BEFORE THE ILLINOIS POLLUTION CONTROL BOARD

MIDWEST GENERATION, LLC)	
)	
Petitioner,)	PCB 20-38 & 20-39
)	(Thermal Demonstration - Water)
ILLINOIS ENVIRONMENTAL PROTECTION AGENCY)	(Consolidated)
)	
Respondent.)

MIDWEST GENERATION, LLC JOLIET GENERATING STATION 9 AND JOLIET GENERATING STATION 29 ALTERNATIVE THERMAL EFFLUENT LIMITATION DEMONSTRATION RESPONSES TO ILLINOIS POLLUTION CONTROL BOARD QUESTIONS FOR PETITIONER.

As requested, a summary of Pallid Shiner numbers is included below. Totals include all samples for the entire LDPR study area below the two Joliet stations (this information was also included in tabular form in Table C-7 of Demonstration Appendix C):

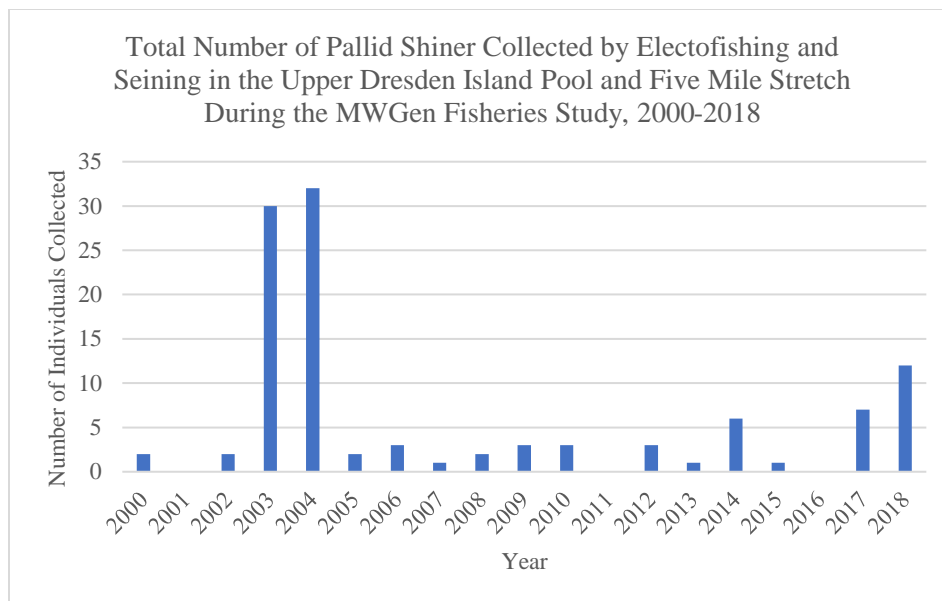
7. The Demonstration notes that catches of Pallid Shiner, a state-endangered species in Illinois, were highest in 2003 and 2004 but catches have since declined because expansion of aquatic macrophytes has reduced sampling efficiency in the Five-Mile Stretch. Demonstration at 4-9. Please comment in detail on how sampling efficiency has been affected by aquatic macrophytes.

Also, please summarize the sampling data to show whether the numbers for Pallid Shiner show an upward or downward trend since it was first caught in the study area.

RESPONSE: The language used in the Demonstration regarding “decline” was somewhat misrepresentative in that what was observed is not an actual population decline; there were two years (2003-2004) when the number of Pallid Shiner collected was inordinately high. This same pattern was seen in the data collected during the same two years downstream near the Dresden Nuclear Power Station.³ In most years, catches in the Upper Dresden Island Pool (UDIP) study area have ranged from none to three, with a slight increase in recent years. The first record of Pallid Shiner occurred in the MWGen study area in 2000 (2001 was incorrect in the Demonstration Summary at Page 4-9).

Additional information on this species, found in the Demonstration Summary Document on Page 4-14 (second to last paragraph), shows that Pallid Shiner has been consistently found in low numbers throughout the UDIP study area. As a state-listed endangered species, low numbers would be expected, but catches may also be further influenced by the dense aquatic plant growth (i.e., aquatic macrophytes expansion) in some sampling locations, which makes it difficult for biologists to get into the sampling areas and/or to collect fish by electrofishing and seining. This limits the effectiveness of sampling by restricting the overall sampling area and/or reducing sampling efficiency. This reduced sampling efficiency can affect overall catch rates for many species.⁴

These data indicate a slight increase in the number of Pallid Shiner collected from the UDIP and Five-Mile Stretch study areas in 2017 and 2018. Most of these were collected closer to the Kankakee River where more suitable habitat exists for this species.
